The DFE Eye Diagram

IEEE 802.3dj May Meeting

Comments Addressed: I-394

Proposed Changes to Figure 180-11

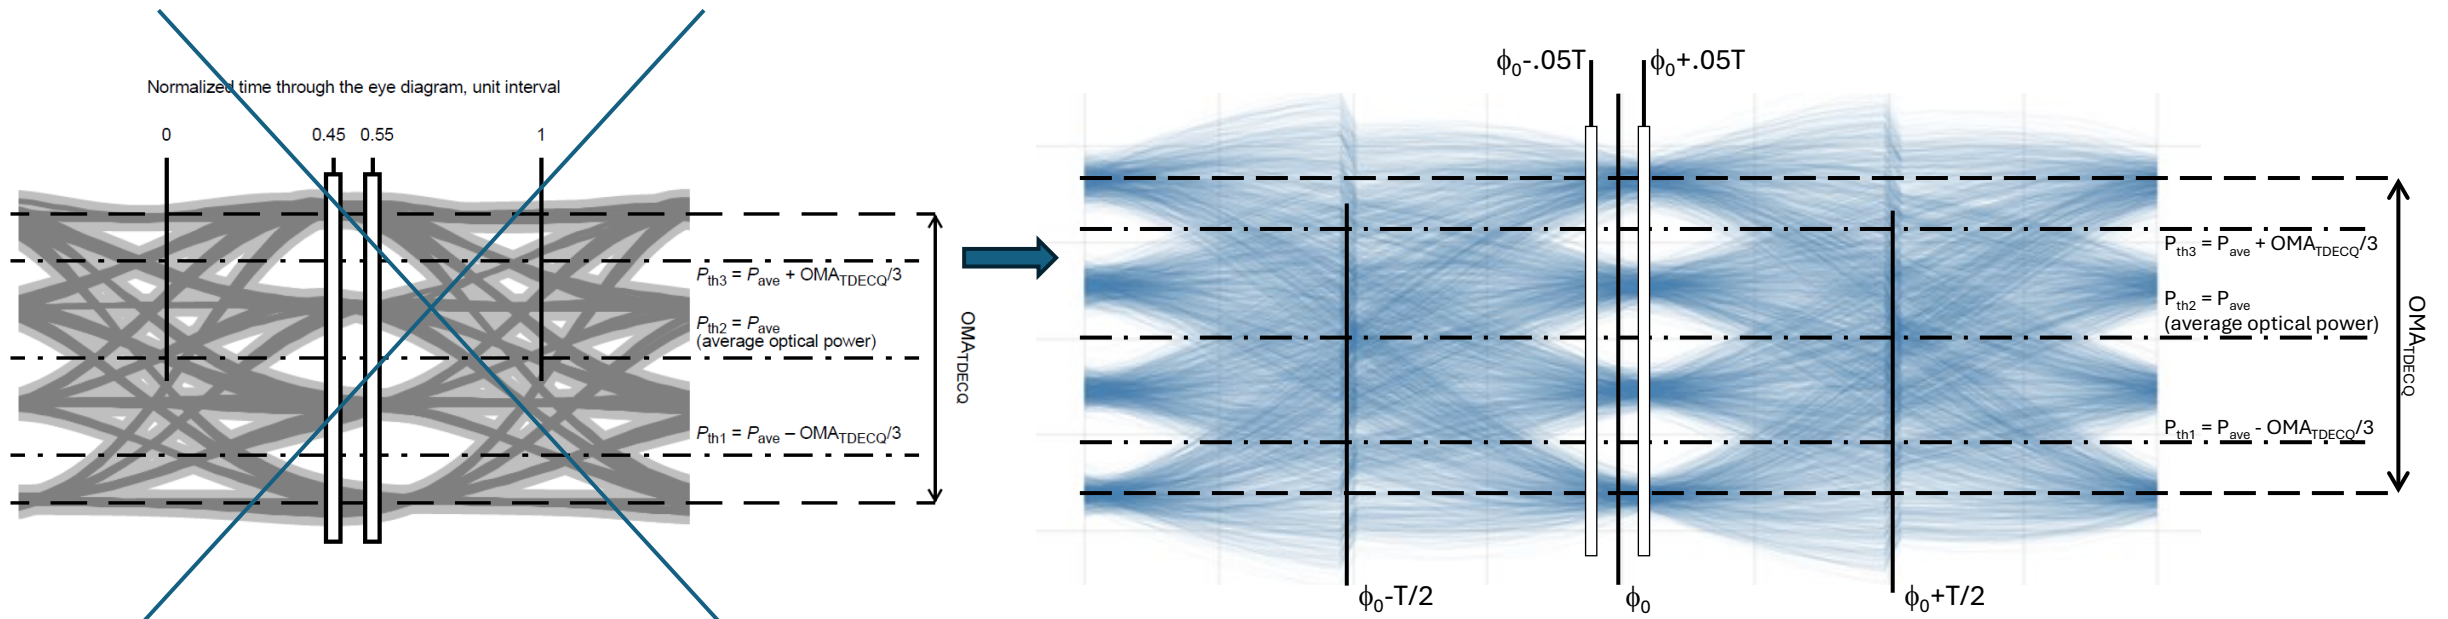
- New figure shows the “batwings” associated with the DFE and the relation to the sampling phase ϕ_0 at which the taps are optimized.

Figure 180–10—TDECQ reference equalizer functional model

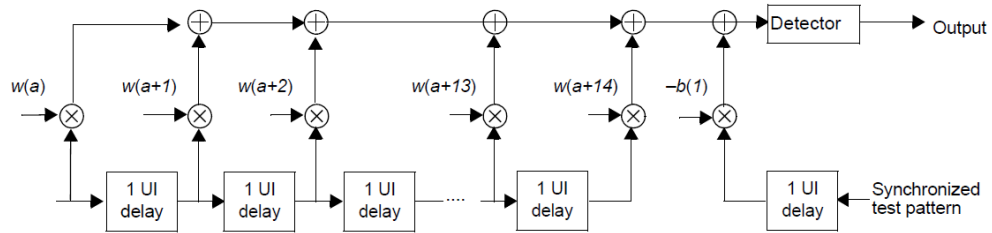
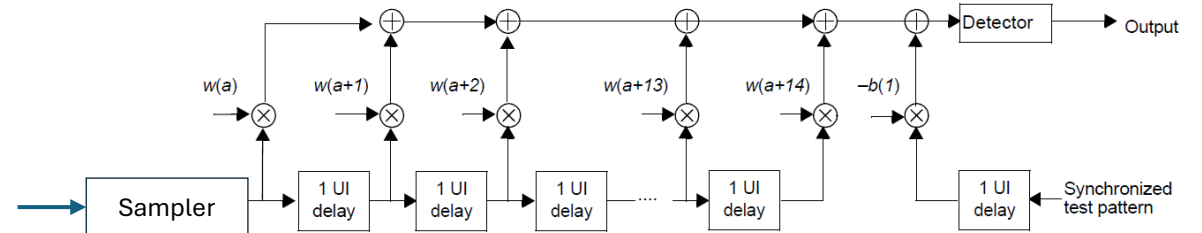
- 1) Continuous time equalizer

- Taps are adjusted based on 1UI - spaced samples
- Components shown are ideal (infinite bandwidth)

- 2) Discrete time equalizer

- 1UI –spaced Sampler is at the input
- For a given tap setting, the phase of the sampler can be swept to produce the eye diagram

Figure 180-11—Illustration of the TDECQ measurement

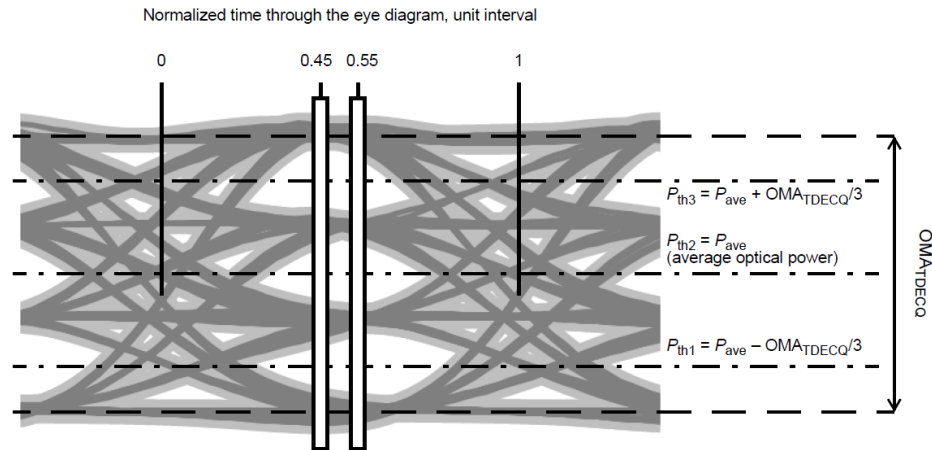
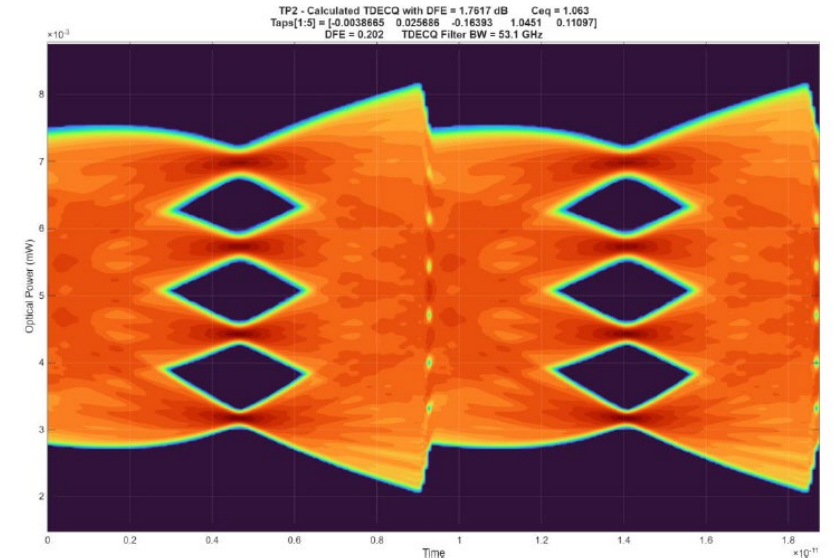
- However we define it, we need to include the “bat-wing” if we show the eye diagram
 - This is a unique feature of the DFE eye diagram. The amount added to the waveform is constant over 1UI.
- Timing: The value must change outside of the two histogram windows
 - Nominally 1/2 UI from the center eye opening is a good choice
 - We need to say something about this in the text
 - Perhaps “1/2 UI from the nominal point at which the TDECQ is measured”
 - This needs better description in the text and figure

Suggested remedy: Delete the eye diagram. Or if we keep it, add the “bat-wings”.
